ORDINANCE NO. _____

An ordinance amending Title 30 – Residential Code – of the Los Angeles County Code, by adopting and incorporating, by reference, the 2016 California Residential Code, with certain changes and modifications.

FIGURE R403.1.5
STEPPED FOOTING

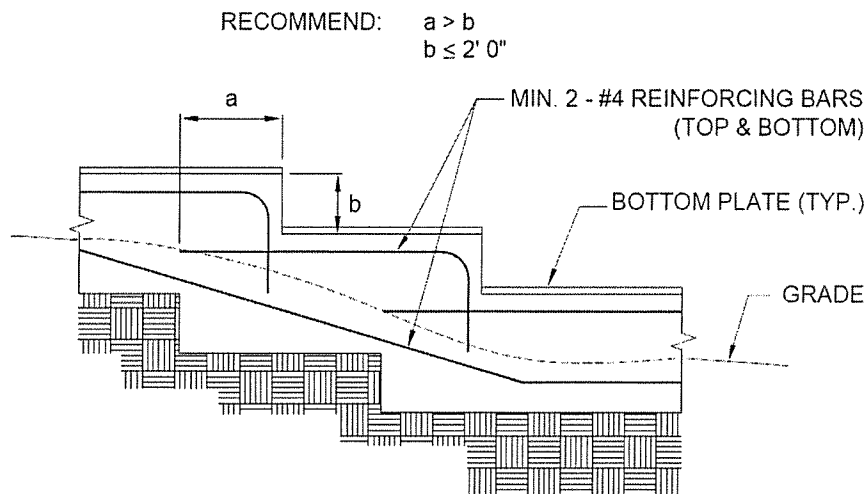
For structures located in Seismic Design Category D₀, D₁, or D₂, stepped footings shall be reinforced with two No. 4 reinforcing bars. Two bars shall be located at the top and bottom of the footings as shown in Figure R403.1.5.

SECTION 30. Figure R403.1.5 is hereby added to read as follows:

R403.1.2 R403.1.3.6 R403.1.5 Figure R403.1.5	Climatic Geological	Los Angeles County is prone to seismic activity due to the existence of active faults in the Southern California area. These proposed amendments require minimum reinforcement in continuous footings and stepped footings to address the problem of poor performance of plain or under-reinforced footings during a seismic event. These amendments implement the recommendations of SEAOSC and the Los Angeles City Joint Task Force resulting from their investigation of the 1994 Northridge Earthquake.

FIGURE R503.2.4

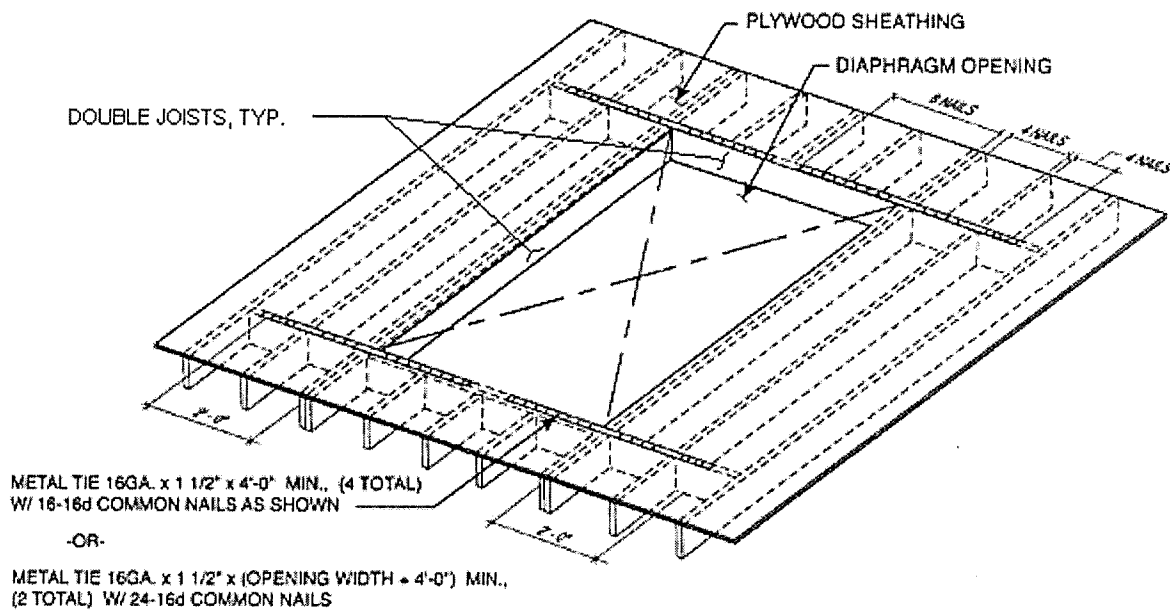
Openings in horizontal diaphragms with a dimension perpendicular to the joist that is greater than 4 feet (1.2 m) shall be constructed in accordance with Figure R503.2.4.

SECTION 34. Figure R503.2.4 is hereby added to read as follows:

Code Section	Condition	Explanation of Amendment
		proposed amendment that a registered design professional be required to analyze if the floor support is adequate and structurally sound.
R503.2.4 Figure R503.2.4	Geological	Section R502.10 of the Code does not provide any prescriptive criteria to limit the maximum floor opening size nor does Section R503 provide any details to address the issue of shear transfer near larger floor openings. With the higher seismic demand placed on buildings and structures in this region, it is important to ensure that a complete load path is provided to reduce or eliminate potential damage caused by seismic forces. Requiring blocking with metal ties around larger floor openings and limiting opening size is consistent with the requirements of Section R301.2.2.2.5.
R602.3.2	Geological	Los Angeles County is prone to seismic activity due to the existence of active faults in the Southern California area. The County of the Los Angeles and cities in this region have taken extra measures to maintain the structural integrity of the framing of the shear walls when designed for high levels of seismic loads by eliminating single top plate construction. The performance of modern day braced wall panel construction is directly related to an adequate load path extending from the roof diaphragm to the foundation system.

FIGURE R602.10.6.1
METHOD ABW—ALTERNATE BRACED WALL PANEL

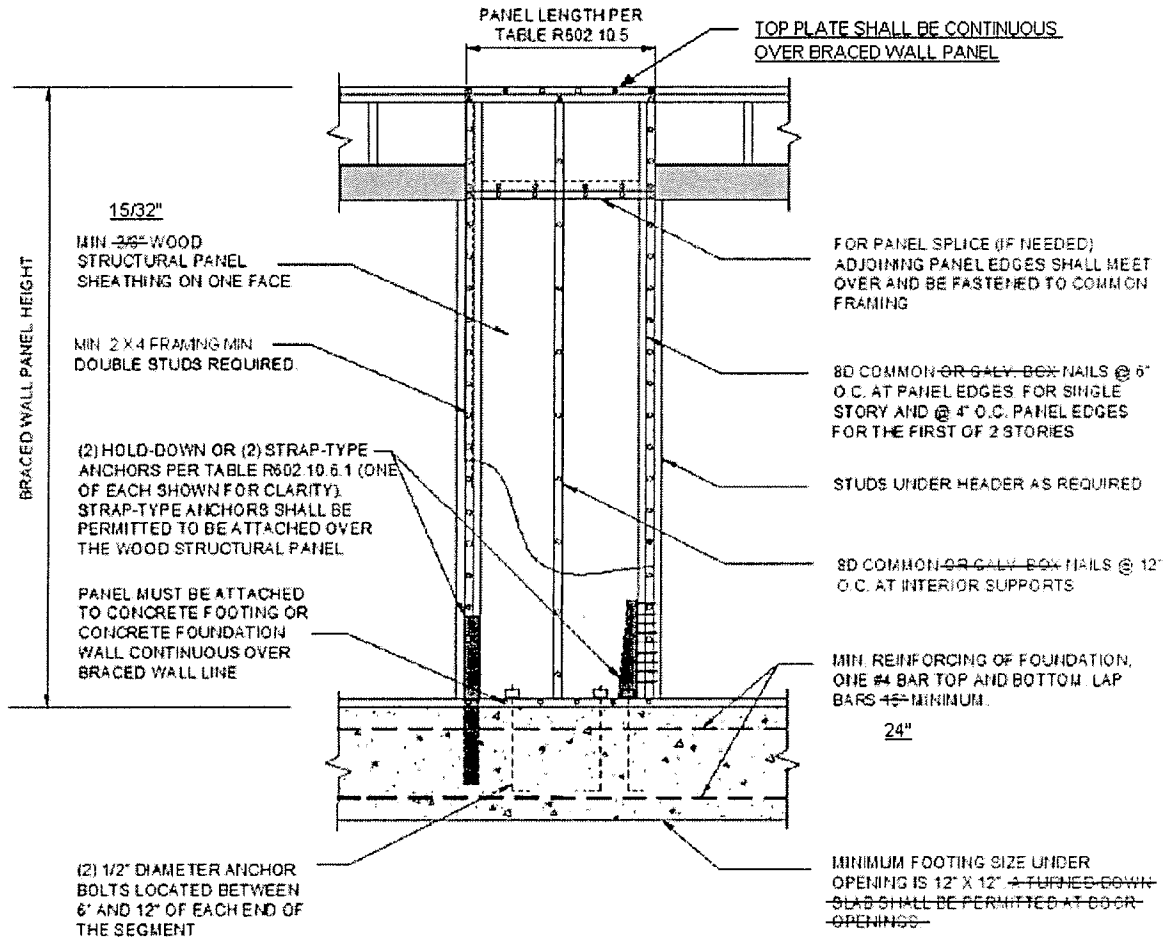
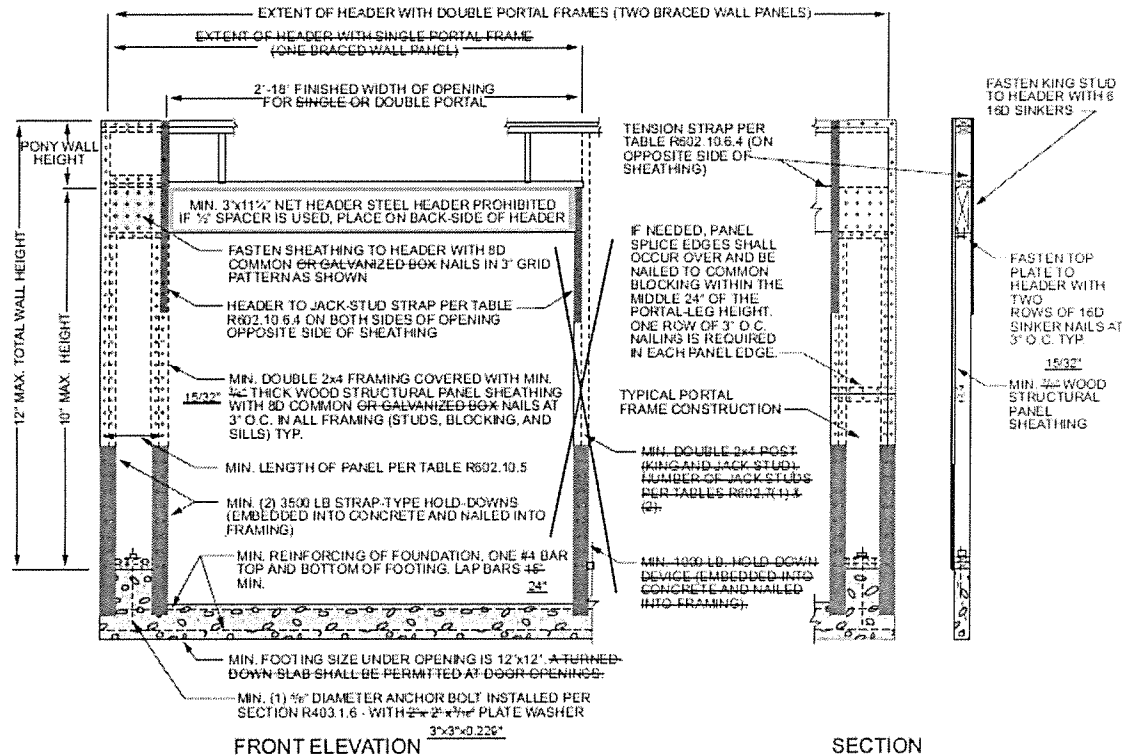
SECTION 42.

Figure R602.10.6.1 is amended to read as follows:

consistent with the shear wall aspect ratio provision of Section 4.3.4 of AWC SDPWS-2015.
Figure R602.10.6.1	Geological	3/8" thick 3 ply-plywood shear walls experienced many failures during the Northridge Earthquake. The poor performance of shear walls in the 1994 Northridge Earthquake was investigated by SEAOSC and the Los Angeles City Joint Task Force. Box nails were observed to cause massive and multiple failures of the typical 3/8" thick 3 ply-plywood during the Northridge Earthquake. The County of the Los Angeles and cities in this region have taken extra measures to maintain the structural integrity of the framing of the shear walls when designed for high levels of seismic loads. The performance of modern day braced wall panel construction is directly related to an adequate load path extending from the roof diaphragm to the foundation system.
Figure R602.10.6.2	Geological	3/8" thick 3 ply-plywood shear walls experienced many failures during the Northridge Earthquake. The poor performance of such shear walls sheathed in the 1994 Northridge Earthquake was investigated by SEAOSC and the Los Angeles City Joint Task Force. The County of the Los Angeles and cities in this region have taken extra measures to maintain the structural integrity of the framing of the shear walls when designed for high levels of seismic loads. Box nails were observed to cause massive and multiple failures of the typical 3/8-inch thick plywood during the Northridge Earthquake. The proposal to change the minimum lap splice requirement is consistent with Section 12.16.1 of ACI 318-11. This proposed amendment is a continuation of an amendment adopted during the previous Code adoption cycles.

FIGURE R602.10.6.2
METHOD PFH—PORTAL FRAME WITH HOLD-DOWNS
AT DETACHED GARAGE DOOR OPENINGS

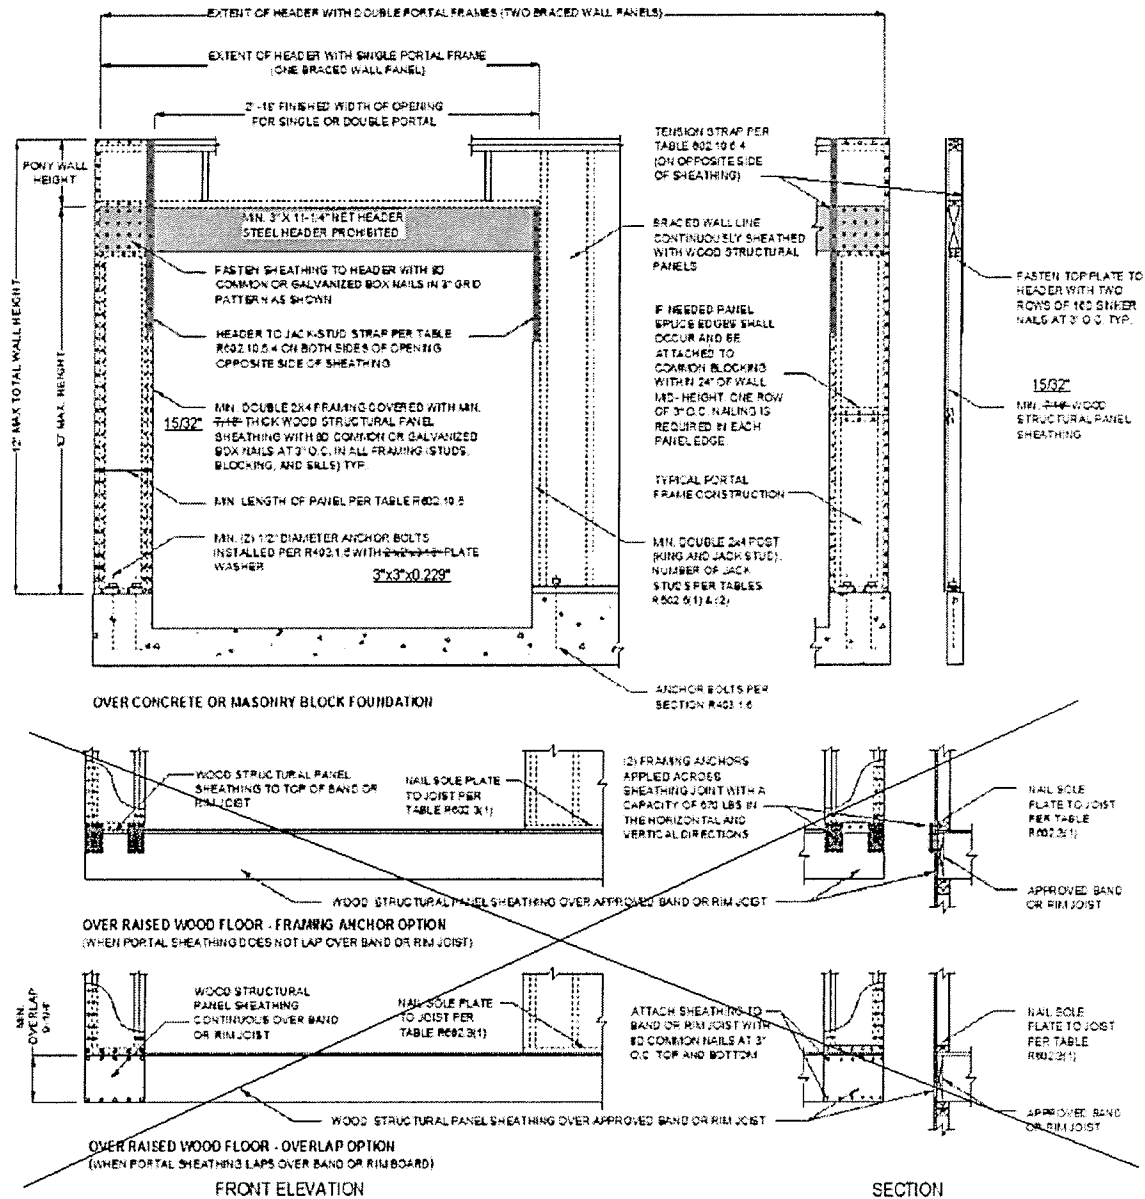
SECTION 43. Figure R602.10.6.2 is hereby amended to read as follows:
